# Technical Service Bulletin

## 24DB UPDATE – TCM Software (FED\_EMS)

August 10, 2018

Model(s)	Year	VIN Range	Vehicle-Specific Equipment
A3	2017	See ELSA	See ELSA

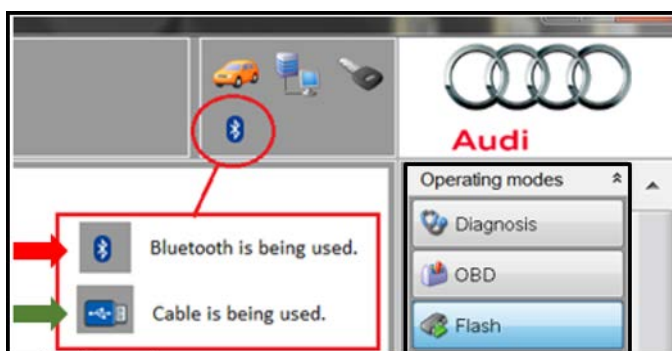
REVISION HISTORY		
Revision	Date	Purpose
1	September 04, 2017	Original publication
2	August 10, 2018	Updated photo in work instructions to reflect that the “Flash” operating mode must be used.

4. Attach the scan tool to the vehicle using an USB cable.
5. Confirm that the scan tool is communicating with the diagnostic head by USB <Green Arrow>. If the Bluetooth symbol is shown <Red Arrow> then disconnect the diagnostic head from the vehicle and then reattach the USB cable to the diagnostic head and then reattach to the vehicle.

6. Using ***Flash***, perform the update using the SVM action code, **24DBA064**.
